UNITED STATES PATENT AND TRADEMARK OFFICE

APPLICATION NO.	FILING DATE	FIRST NAMED INVENTOR	ATTORNEY DOCKET NO.	CONFIRMATION NO.
10/826,190	04/15/2004	Thomas P. Vickery	21384Y	9809
210	7590	10/20/2005	EXAMINER	
MERCK AND CO., INC P O BOX 2000 RAHWAY, NJ 07065-0907			GARBER, CHARLES D	
			ART UNIT	PAPER NUMBER
			2856

Office Action Summary

DETAILED ACTION

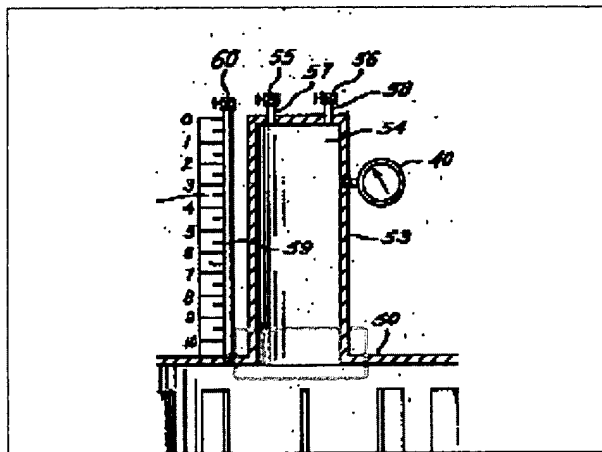
Referring to Myers figure 3, container 10 is cylindrical vessel having openings at the top and bottom. It appears capable of holding a volume of a liquid capable of generating a gas.

The area highlighted below is a first port in cylinder 53. Gauge 40 is a pressure gauge which is a pressure reading means attached to a second port and valves 55 and 56 are valve means and pressure relief means respectively connected to third and forth ports in the cylinder 53. The cylinder may be considered to be a multi-port connector as in the instant invention.

Stuffing box 16, apparent in both of the Myers embodiments, may be considered a plugging means plugging the hole through which stirring shaft 15 passes in order to form a fluid tight seal.
